PRODUCT / PROCESS CHANGE NOTIFICATION

1.1 Company		STMicroelectronics International N.V
1.2 PCN No.	ADG/18/11071	
1.3 Title of PCN	M10 Microcontrollers Family: Assembly of LQFP 64L Package and Final Test Transfer from ST Malta to ST Muar (ST Line FP40)	
1.4 Product Category	see list	
1.5 Issue date	2018-09-13

SUBJECT **M10 MICROCONTROLLERS FAMILY: ASSEMBLY OF LQFP 64L PACKAGE AND FINAL TEST TRANSFER FROM ST MALTA TO ST MUAR – ST LINE FP40**

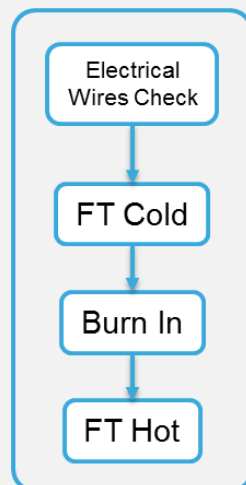
Regarding package assembly, opportunity has been taken to implement latest solutions adopting a High Density leadframes matrix, already in use in ST Muar for this type of package.

As far as materials are concerned, following Bill Of Material improvements have been implemented (see below table for comparison):

ST Malta	ST Muar
Leadframe	LQFP 64L 10x10 6sq C7025 OptG SpAg	LQFP 64L 10SQ 5.17sqOpA SpAg+TNCU3
Resin	SUMITOMO EME-G700L/LS	SUMITOMO EME-G700LS
Glue	ABLESTIK QMI9507	ABLESTIK QMI9507
Wire	WIRE CuPd CLR3 D0.7	WIRE CuPd CLR3 D0.7
